November 26, 2018

**PERFORMANCE BULLETIN 103**

**V42 & VAV Series Shaft Guide Update**

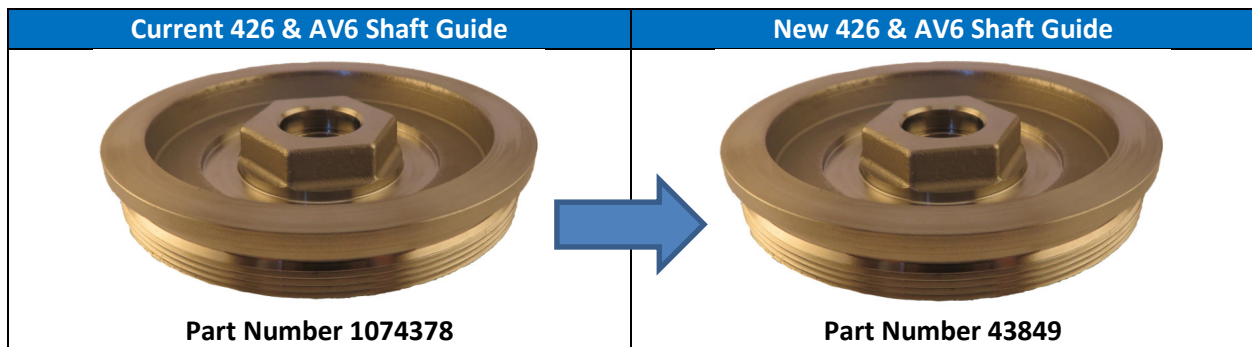
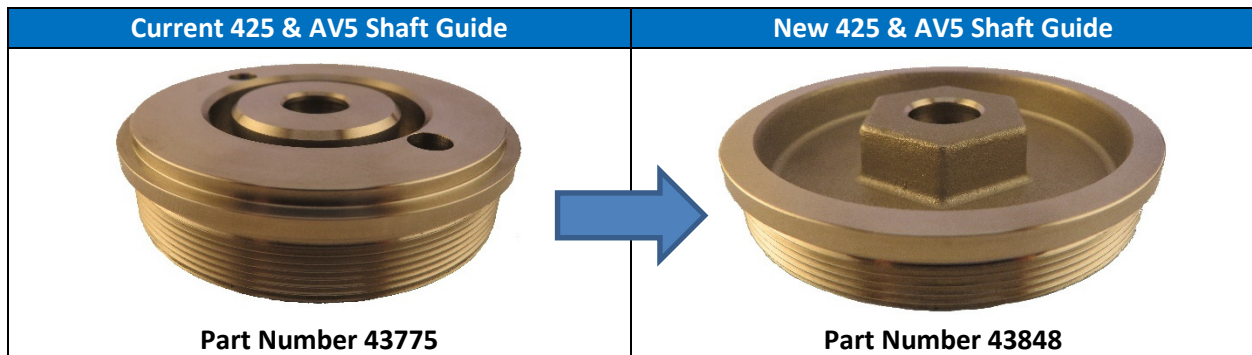
Shaft Guides for 2" and 3" metal valves (V425, VAV5, V426, VAV6, V427, and VAV7) are being updated to use a new investment cast design. The fit, and function of the parts will remain unaffected and the new Shaft Guides will be fully interchangeable with the old.

The new style Shaft Guides will feature a 1.25" hex for easy removal and maintain the dual shaft oring design for improved shaft alignment. The Shaft Guides will remain 303 Stainless Steel material. As a result of this update, the Part Numbers will be changed as shown below. Kits containing the Shaft Guides will not change Part Numbers. The update will be implemented when inventory of the current machined version is exhausted.
